Analysis of the Tongue River Railroad Draft Environmental Impact Statement

Prepared for Sierra Club and Earthjustice

September 23, 2015

Synapse
Energy Economics, Inc.

Figure 3: DEIS Tongue River coal production, by scenario (million tons/year)

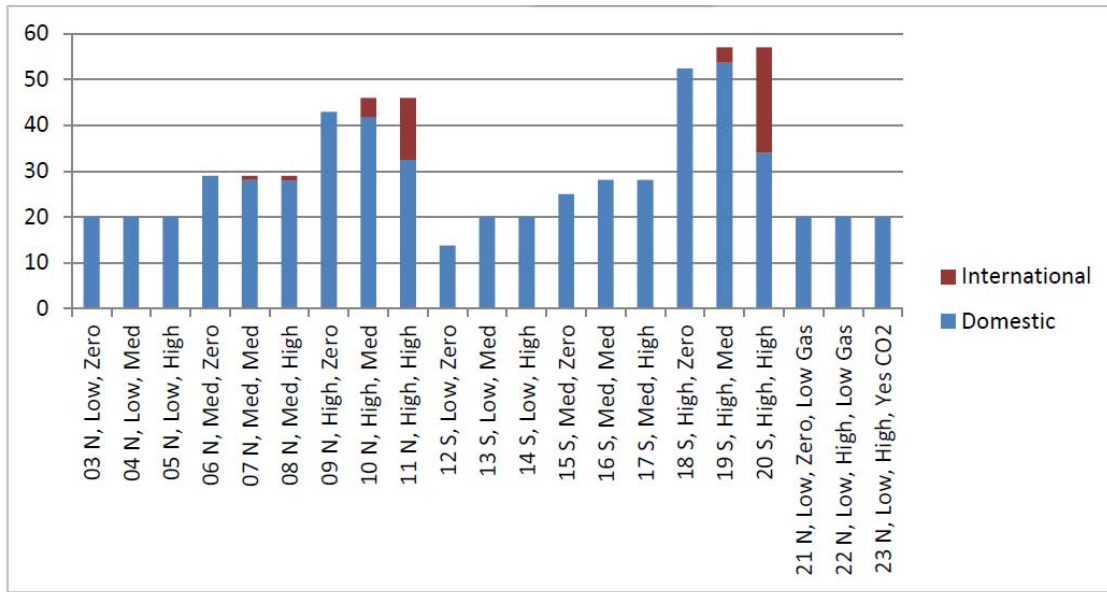
In most of the scenarios analyzed by STB, no coal from Tongue River is exported. Figure 3 shows the annual average domestic and international coal deliveries from Tongue River in the DEIS modeling. In one scenario the share of coal exported is 40 percent (scenario 20) but for most scenarios, all of the coal that is produced is sold domestically. For the northern rail alternative (noted as "N" in Figure 3), those scenarios with the highest share of exports (10 and 11) have the highest total production. The same is true for the southern alternative (noted as "S" in Figure 3), where scenario 19 and 20 have both the highest share of exports and total coal production.

Figure 4: Change in U.S. CO₂ emissions from coal and natural gas (million metric tons per year)

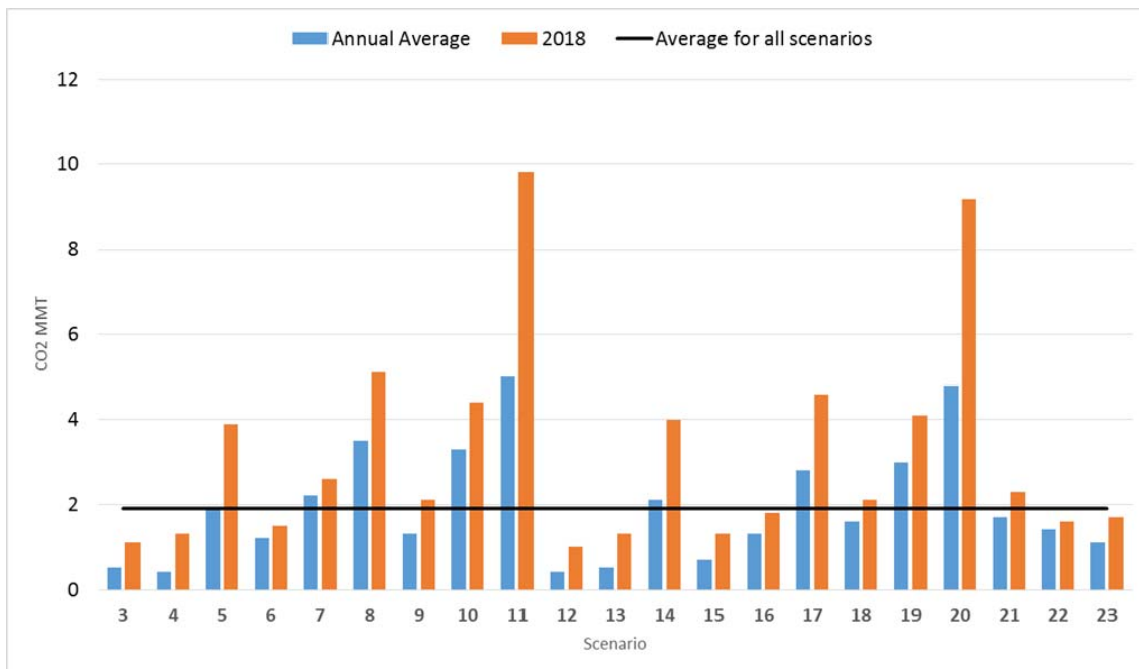
Figure 4 depicts the change in U.S. coal and natural gas emissions from the perspective of the annual average, the emissions in 2018, and the average across all scenarios. On average, those scenarios with high shares of exports (11 and 20) generate about 5 million tons of CO₂ per year. In 2018, they each generate approximately double that: nearly 10 million metric tons in scenario 11 and 9 million tons in scenario 20. In both cases, this emission result is much higher than the 1.9 million metric ton average across all scenarios. Clearly, high coal production capacity and availability of exports lead to higher CO₂ emissions impacts of Tongue River coal. STB's results show that more coal would be burned in those scenarios with high international exports. This seems justified based on projections of international coal plant additions, yet there is no scenario in which all Tongue River coal is exported. This seems likely if the Tongue River railroad and the associated coalmines were to be constructed, and this scenario should have been considered and reported in STB's analysis.
